UNITED STATES
NUCLEAR REGULATORY COMMISSION
ADVISORY COMMITTEE ON REACTOR SAFEGUARDS
WASHINGTON, D. C. 20555

January 23, 1984

SUBJECT: ALLEGATIONS REGARDING CONSTRUCTION PRACTICES AT THE
DIABLO CANYON NUCLEAR POWER STATION

PIPE SUPPORT DESIGN TOLERANCE CLARIFICATION FORM

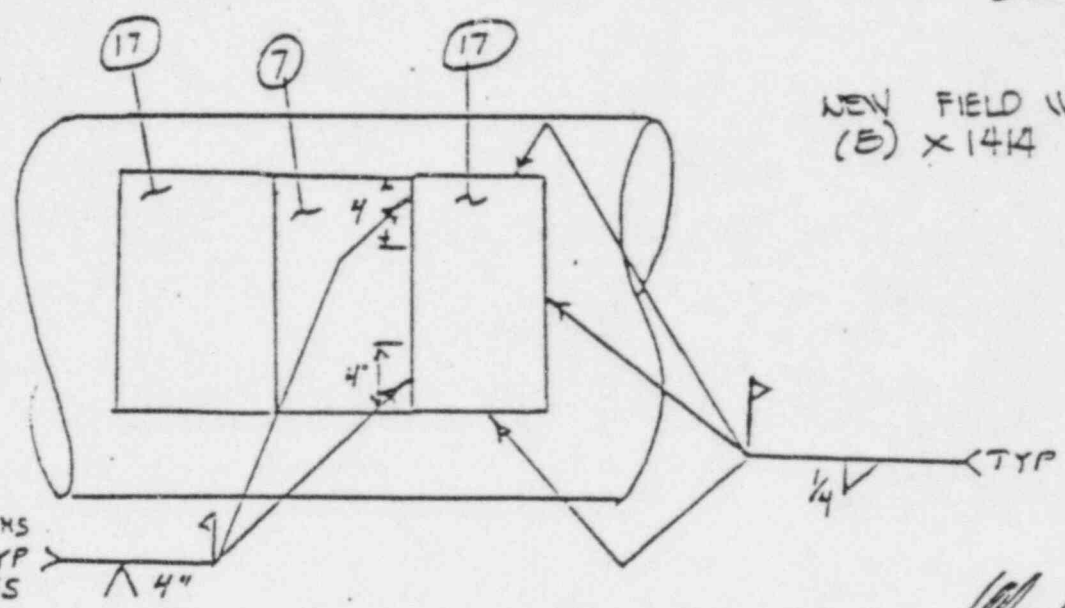
REVISE WELD OF ITEM 17 TO THE PIPE AS SHOWN BELOW --

LOCATION AREA: 1B ELEV: 104'-0" pre-inspect
in-work
past work
DR

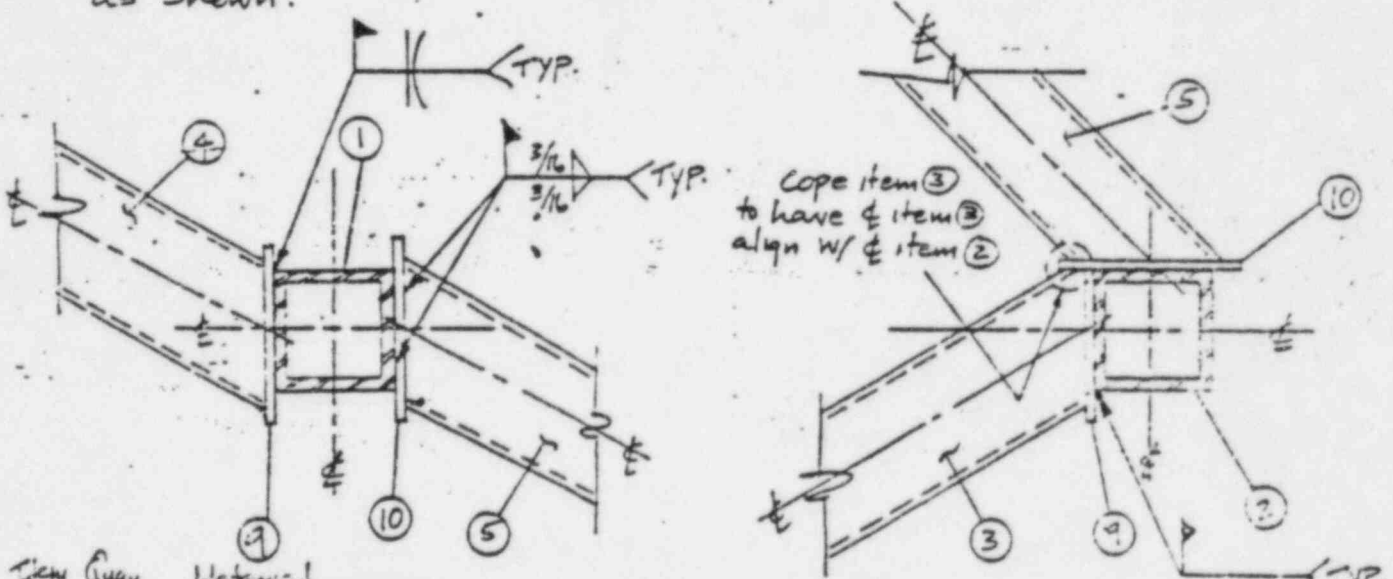
Due to angle cuts on items ③, ④ & ⑤, need to provide end plates to cover overhang when attached to members ① & ②, as shown.

Item	Qty	Material
9	2	PL 1/2" x 7"
10	2	PL 1/2" x 7"

ELEV. VIEW (LKG. NORTH)

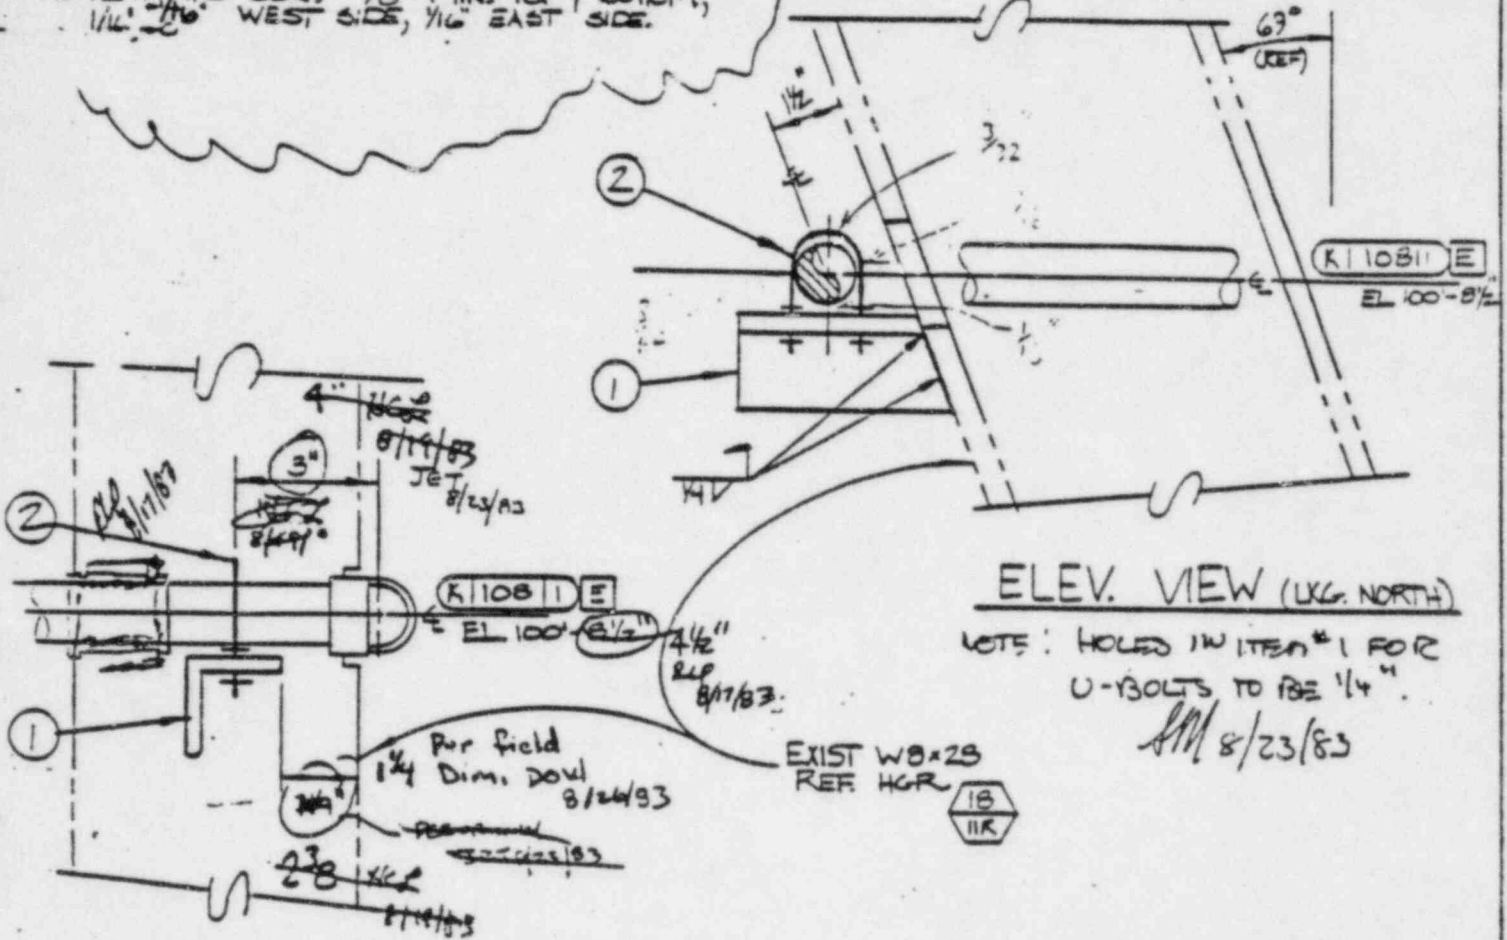
GAPS WERE INCORRECTLY TRANSFERRED EAST AND WEST WEST GAP IS 0". DCN 1604-022 WRITTEN TO REWORK 10/22/83
